GNF-A's NEW POWDER CONTAINER (NPC)

**NRC CERTIFICATE OF COMPLIANCE
USA/9294/AF**

**To Facilitate Review of the September 2002
Submittal**

**ATTACHMENTS 5 & 6 TO THE 9/30/2002
APPLICATION**

Figure 6.2 ICCA Modeled Axial ~~dimensions~~Dimensions

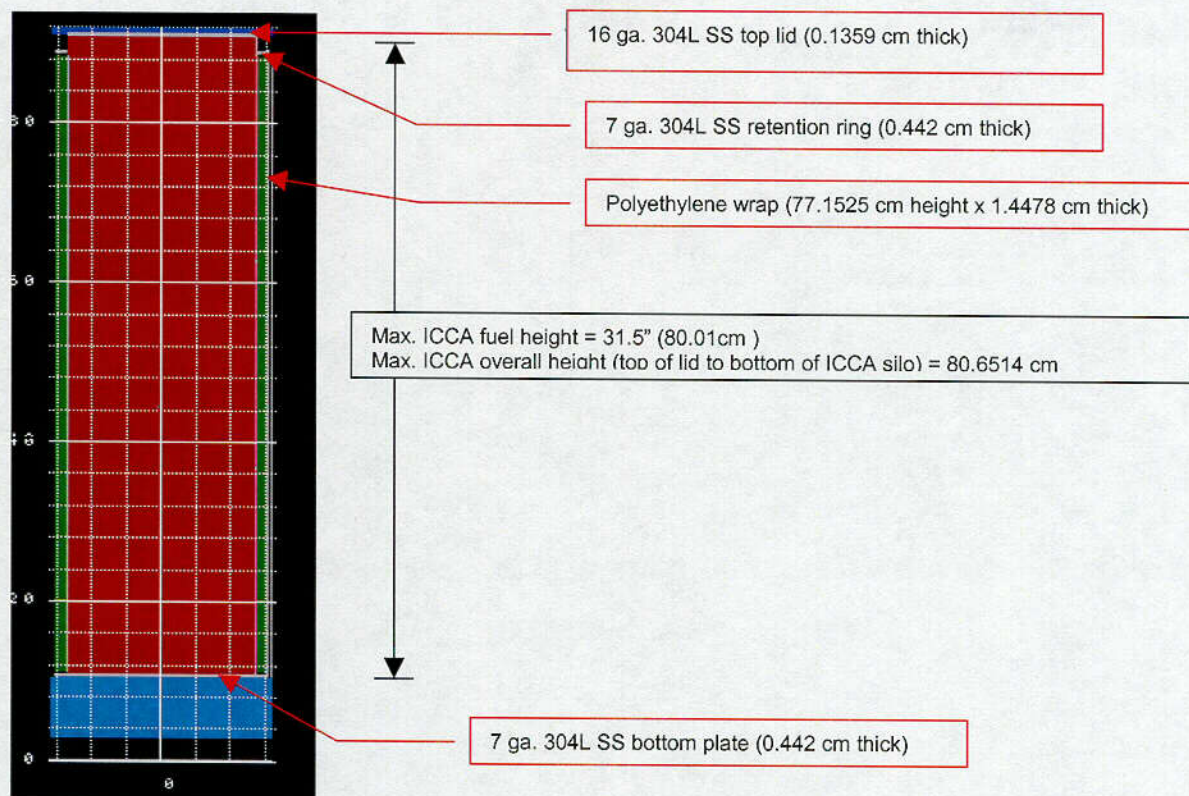
Figure 6.1 shows the material constituent radial dimensions from center of the ICCA ID ($\delta 1$) through outer radius of the contamination shield ($\delta 7$). Figure 6.2 depicts the axial version of the ICCA and contamination shield. The ICCA model construct consists of a stackup of 11 separate axial pieces. This is performed to explicitly include the 1/8" (0.3175 cm) gaps of the high density polyethylene wrap on each end, the maximum axial seam gap tolerance between the three separate 10-1/8" (25.7175 cm) nominal wide cadmium wraps, the axial foam distribution density changes, and the fact that the ICCA silo is installed only in the lower body assembly. The upper section of the ICCA also penetrates the lid assembly to accommodate the vertical ICCA height, lock ring and bolt closure.

Figure 6.7a – Infinite undamaged array: 60 kgs UO_2 + 15% H_2O , theoretical mixture

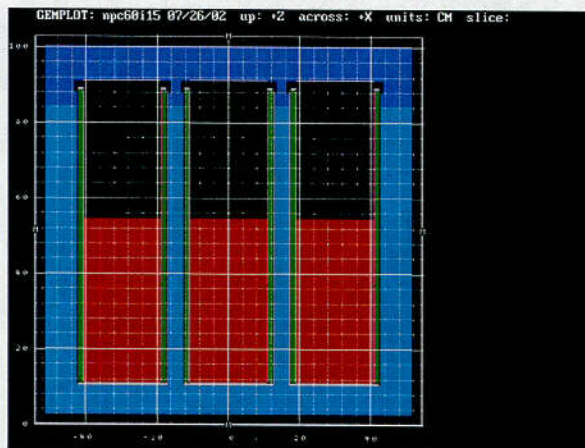
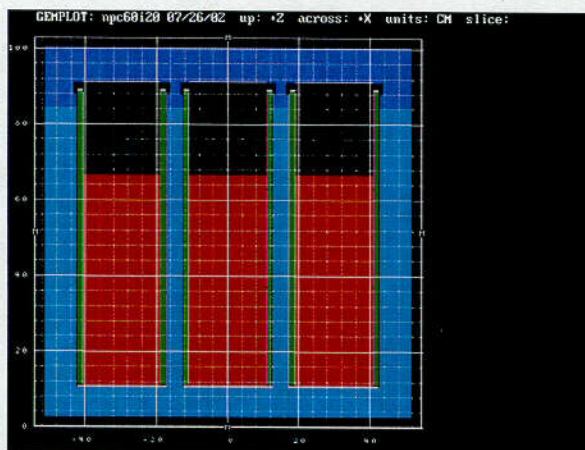
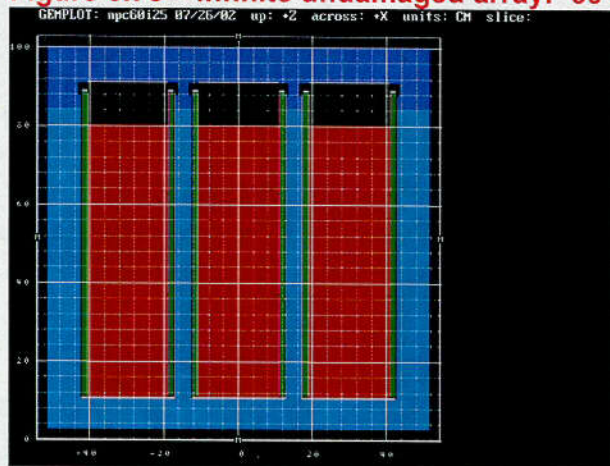
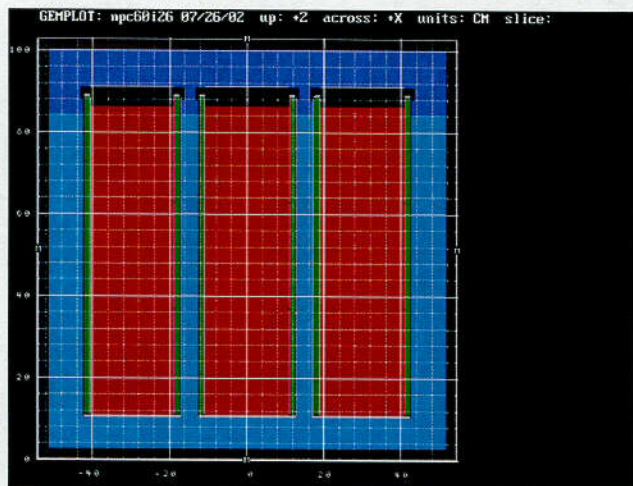
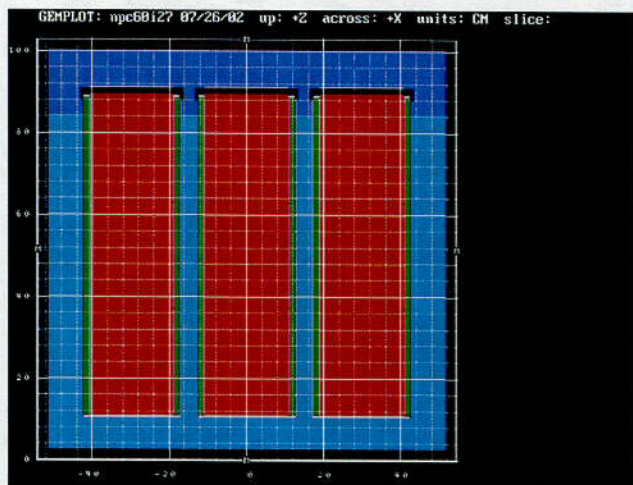
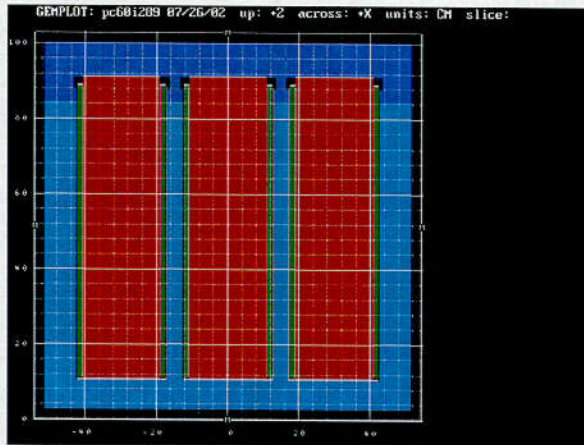
Figures 6.76a-6.76f depicts the models used to assess normal conditions of transport, and show illustrate the resulting increasing fuel height – up to the 80.01 cm maximum – decrease as the UO_2 compound density is increased to the as the weight fraction of H_2O (WF-W) is increased. maximum credible value. In These sample plots, apply to the 60 kg $\text{UO}_2 + 5\% \text{H}_2\text{O}$ mixture is used mass limit.

Figure 6.87a – Fully reflected damaged 5x5x6 package array: 60 kgs $\text{UO}_2 + \text{H}_2\text{O}$ mixture, CTU-1 observed non-uniform burn (horizontal and vertical views)

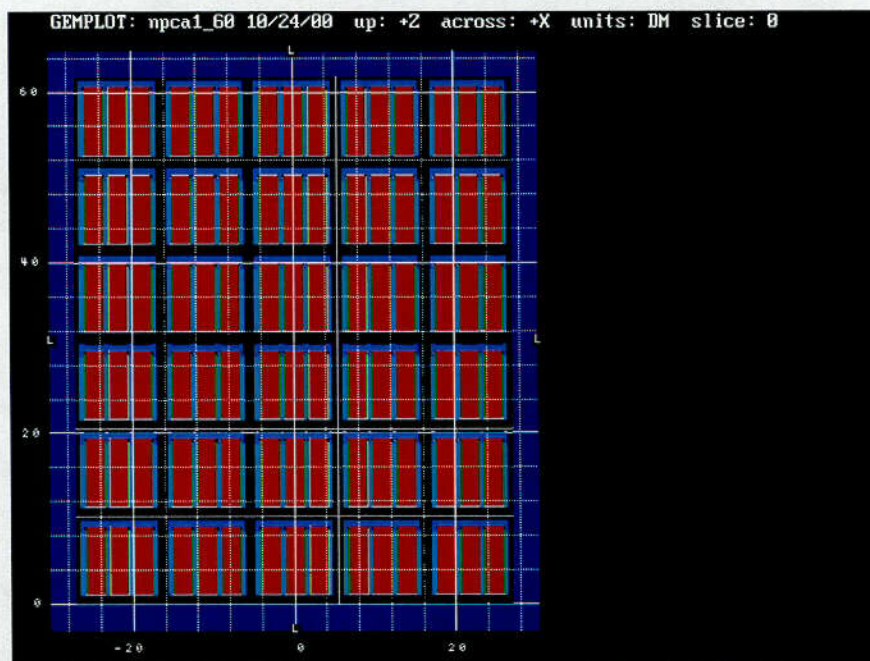
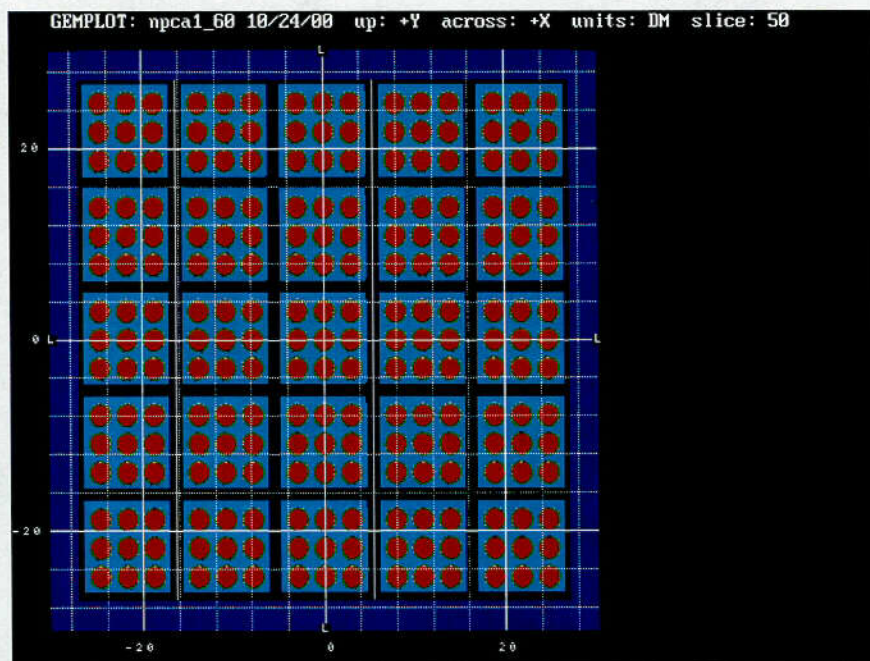
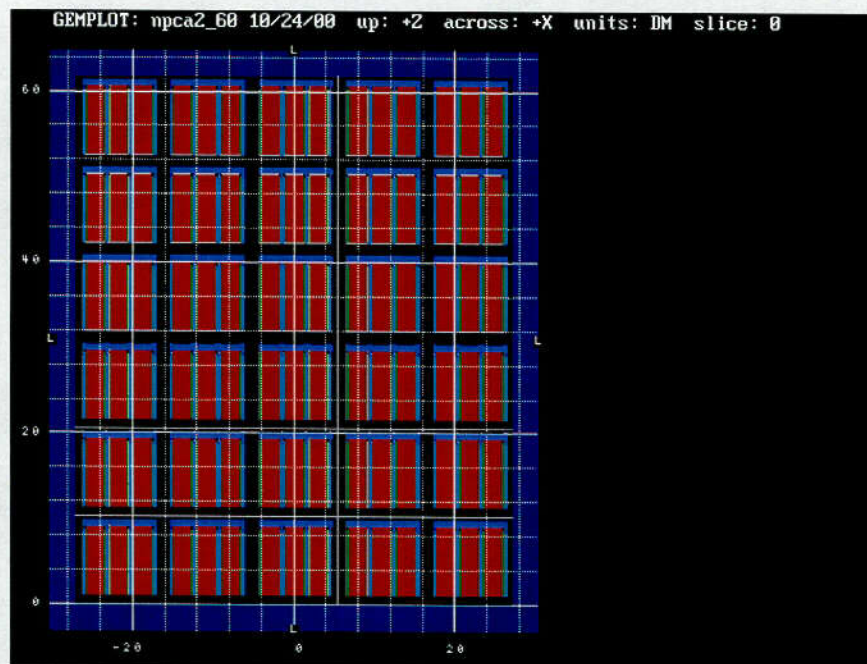
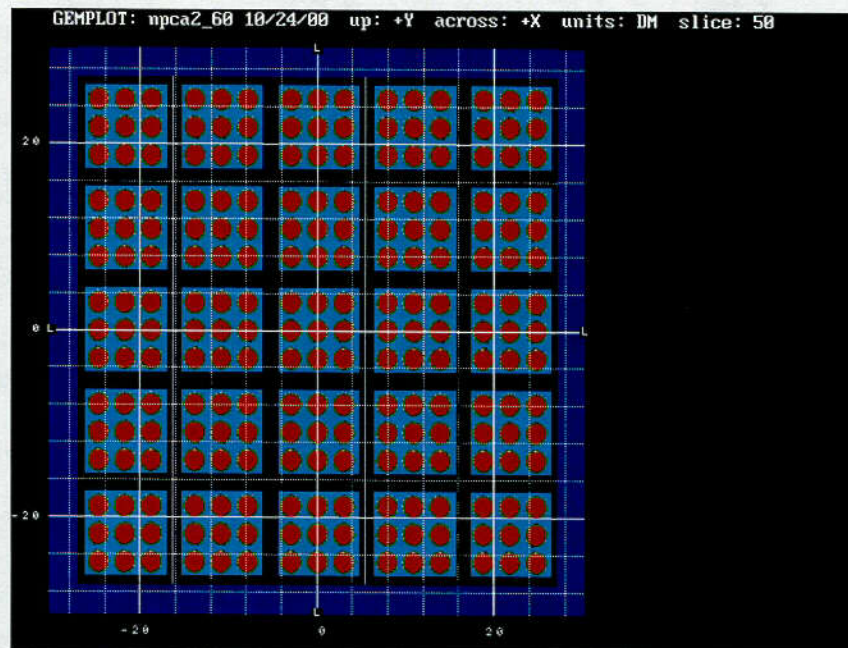
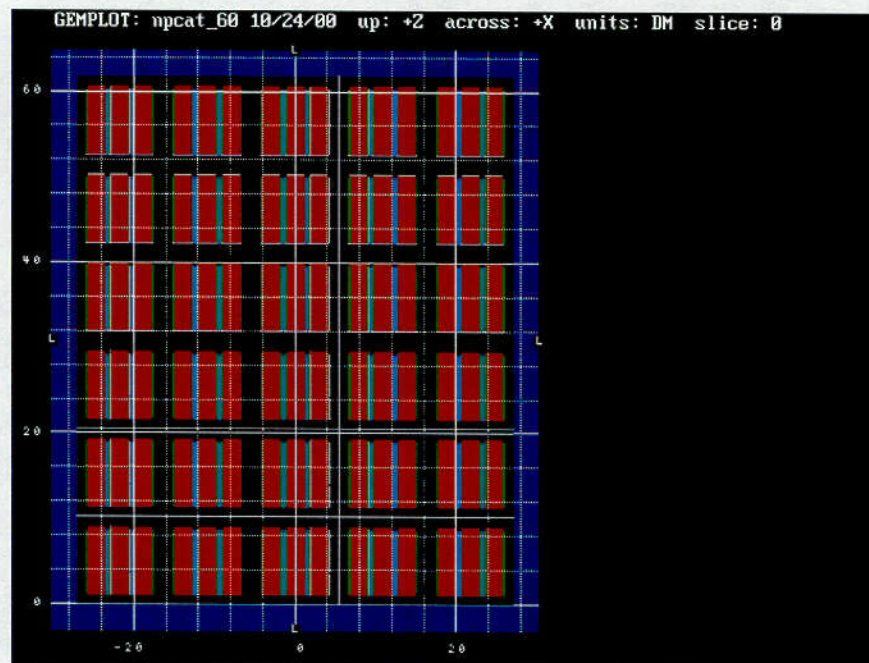
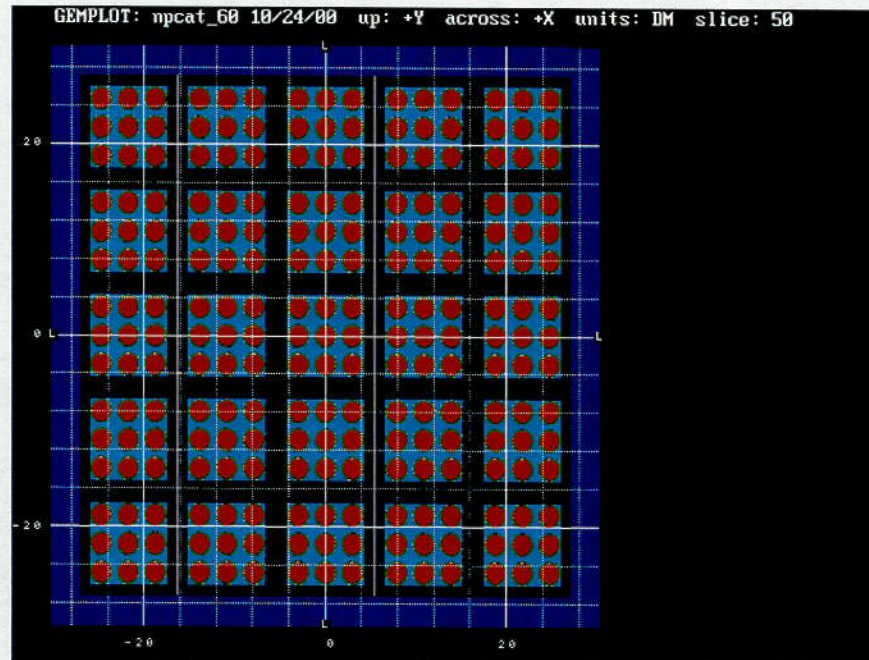
- Figure 6.87a and 6.87b depicts horizontal/vertical slices of the damaged $5 \times 5 \times 6$ package array to determine acceptable UO_2 equivalent payload under postulated damaged conditions of transport, using the observed CTU-1 and CTU-2 non-uniform foam burn conditions, respectively.

- Figure 6.87c depicts horizontal/vertical slices of the damaged $5 \times 5 \times 6$ package array to determine acceptable UO_2 equivalent payload under postulated damaged conditions of transport, applying the maximum burn condition.

Figure 6.109a – Sample k_{eff} convergence: damaged unit – npcut_25.in

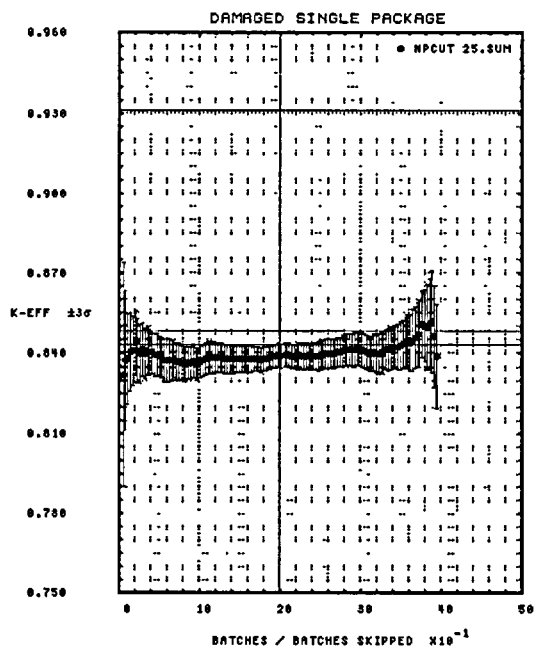
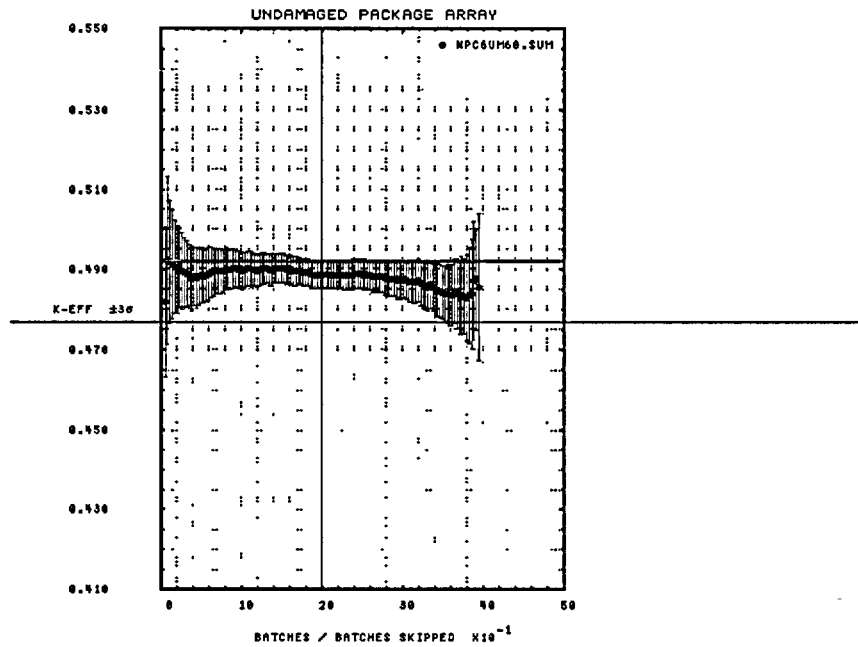
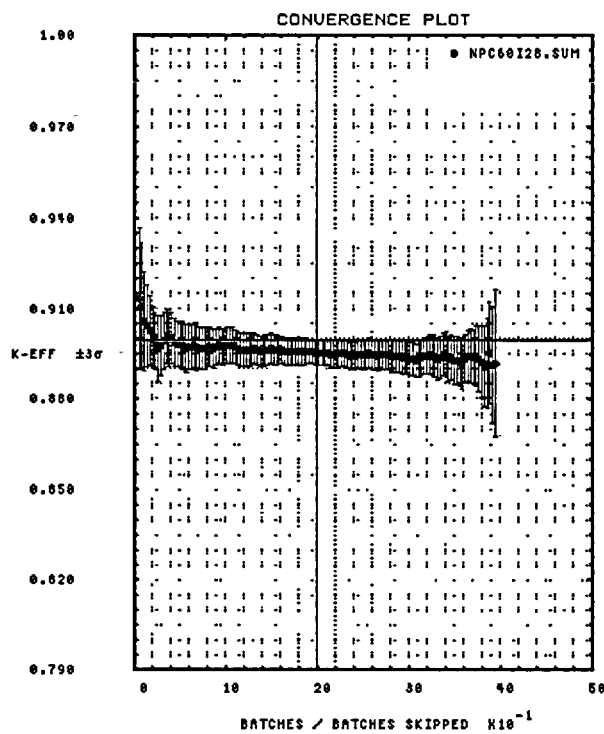
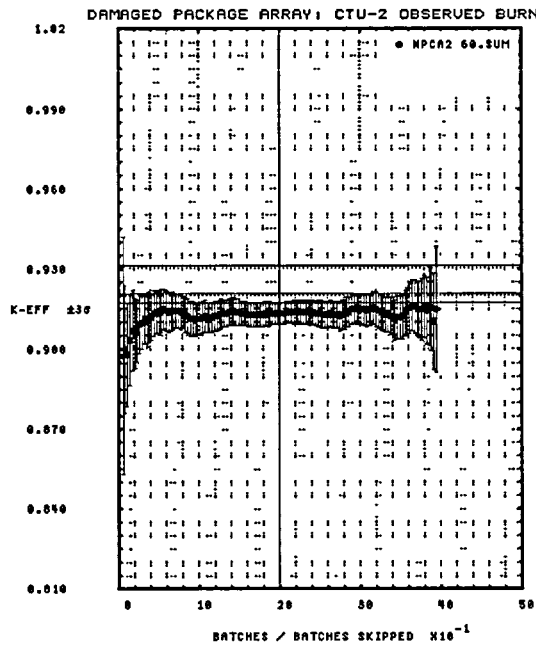
damaged single package, undamaged array, and damaged array models are shown in Figures 6.109a- 6.109d. (The plots shown are for cases with homogeneous UO_2 and H_2O mixtures, but the results are also representative of the results for heterogeneous lattices.)
